Lower Thames Crossing

9.181 Final Statement of Common Ground between (1) National Highways and (2) Stuart Mee & Family (Tracked changes version)

Planning Inspectorate Scheme Ref: TR010032
Examination Document Ref: TR010032/EXAM/9.181

Plate 2.1 PLAN 1 (Manor Farm - Location Plan)

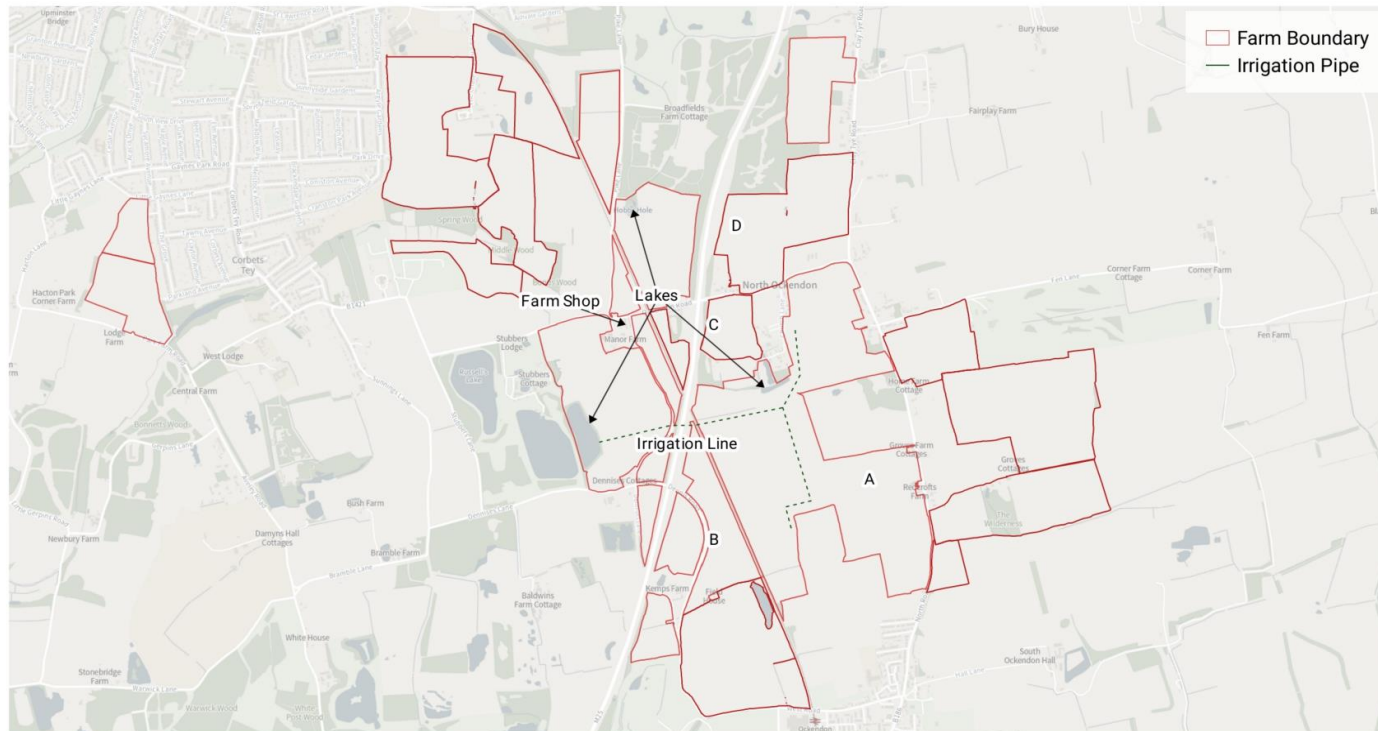
Topic	Item number	Stuart Mee & Family comment (Landowner)	The Applicant's response	Document Reference	Status
		<p>LTC alignment. The irrigation line where it crosses the M25 is illustrated in Plan 1</p> <p>The Landowner has commissioned a specialist water consultant to appraise the predicted impact and possible solutions to provide a viable and suitable alternative system.</p> <p>Understanding what the Applicant is proposing is a specialist piece of work and therefore they need their own Expert in this area. An options report has been sent to the applicant for review and the landowner requests feedback before Deadline 5.</p> <p>The Landowner is encouraged that both parties are finding a solution however, there is concern that there is an unknown on the water flow and levels as a result of the construction of LTC and the Landowner therefore reserves the right for compensation.</p> <p>The Landowner needs this to form part of a protective provision or side legal agreement.</p>	<p>in December 2022 along with an associated rain gauge.</p> <p>The landowner's consultant has provided <u>the Manor Farm Options Report and Manor Farm Options Summary</u> to the Applicant on 20 July 2023 <u>and November 2023 (respectively)</u> which <u>are</u> being reviewed. This will then help to inform a Preferred Option Development Report <u>in due course</u>, the Applicant <u>has committed to the above approach in both SACR-030 and also the draft</u> legal side agreement.</p>	<p><u>Commitments Register [Document Reference 7.21 (7)]</u></p>

Plate 2.6 PLAN 6

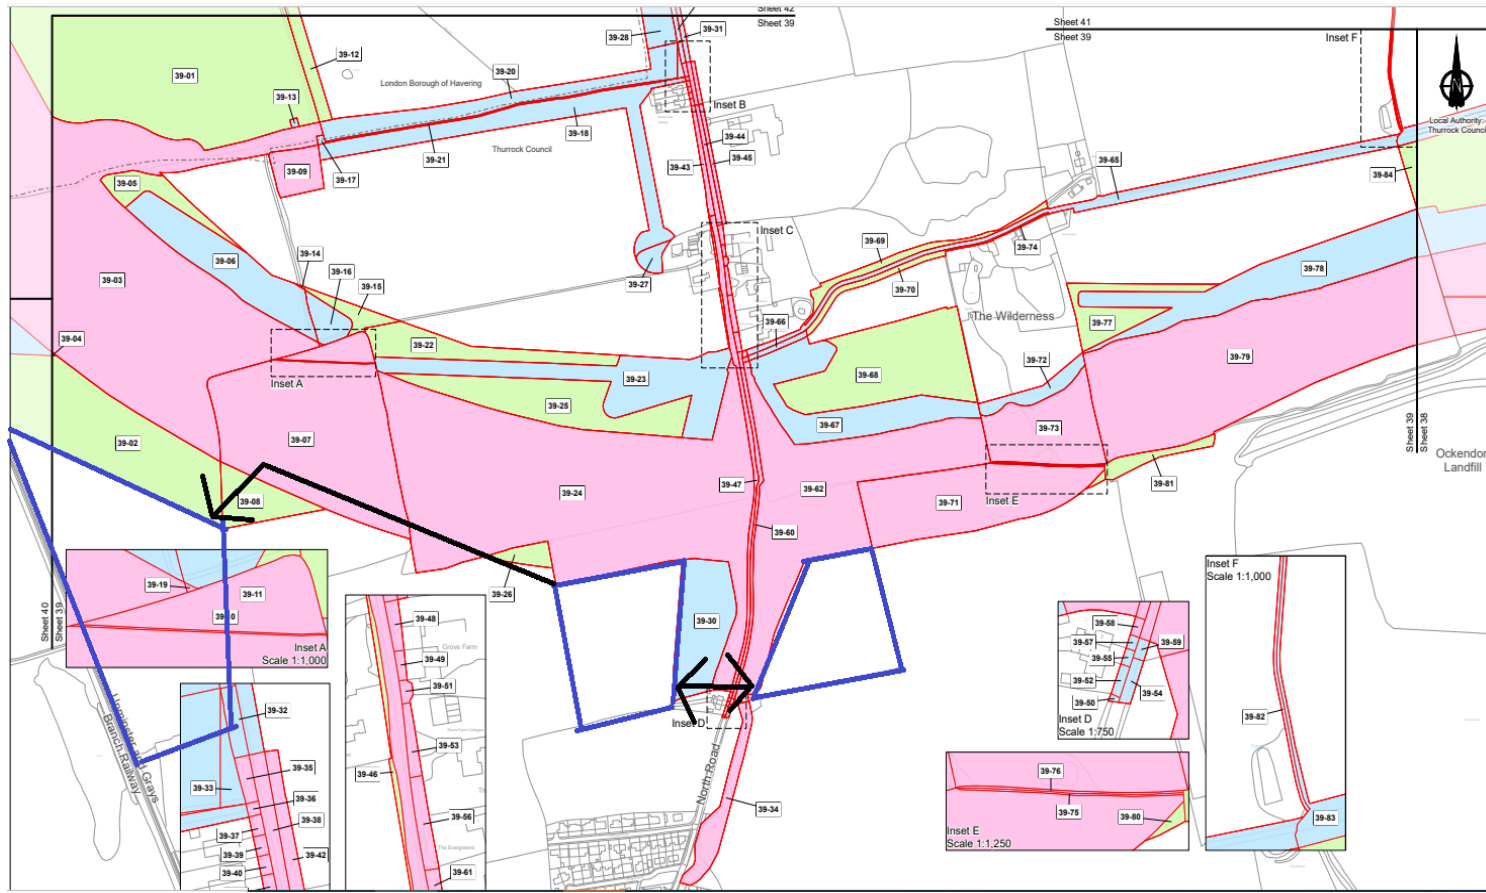
Topic	Item number	Stuart Mee & Family comment (Landowner)	The Applicant's response	Document Reference	Status
Land & Compulsory Acquisition					
Field Accesses	2.1.1	No detail has been provided around the field accesses to the landowners retained land indicated by black arrows into fields edged purple on the Plans 6-8 below in 2.2 Notes are of concern to the Landowner.	SACR-005 in the Stakeholder Actions and Commitments Register (SACR) commits the Contractor to maintain provision for farm access during the construction phase. The Applicant acknowledges the importance of maintaining /	<u>Stakeholder Actions and Commitments Register [Document Reference 7.21 (7)]</u>	Matter <u>Agreed*</u> , <u>Now secured under SACR-031 and also subject to the completion of the legal side</u>

Plate 2.9 PLAN 9

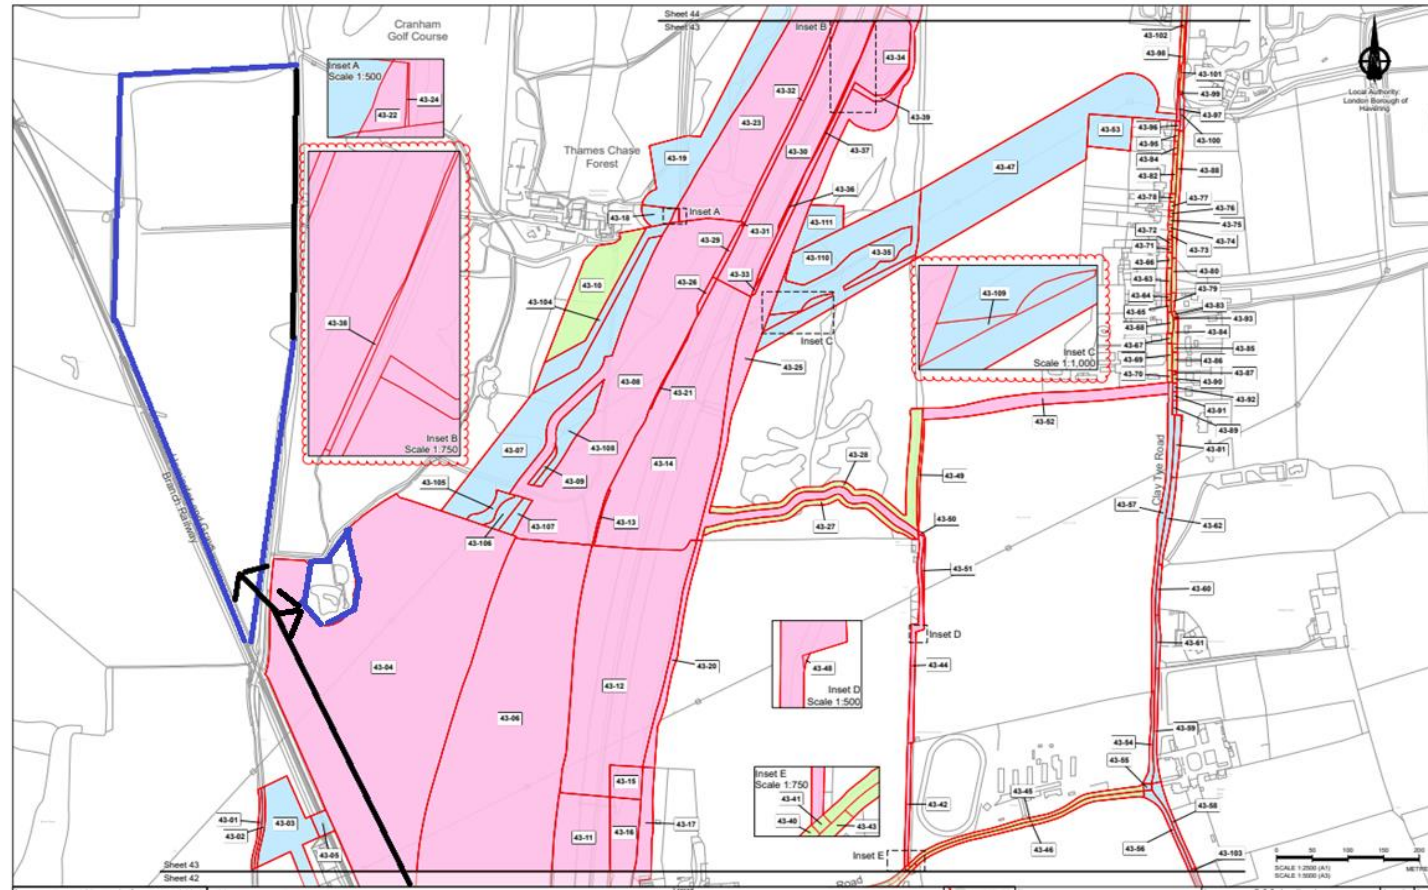
Access off Ockendon Road north across Plot 42-19 & Plot 43-04	2.1.2	<p>No detail has been provided around the field accesses indicated by black arrows into fields and pond edged purple on Plan 9 below in 2.2 Notes are of concern to the Landowner.</p> <p>The Contractors and National Highways (NH) requires a point of access from Ockendon Road which is</p>	<p>The Applicant <u>will transfer</u> the <u>Plots 42-19 and 43-04 to</u> Forestry England <u>and Essex County Council</u> as replacement open space land <u>subject to a permanent right of access from Pike Lane to Hobbs Hole Pond and from Ockendon</u></p>	<p><u>Stakeholder Actions and Commitments Register</u> <u>[Document Reference 7.21 (7)]</u></p>	<p>Matter <u>Agreed*</u></p>
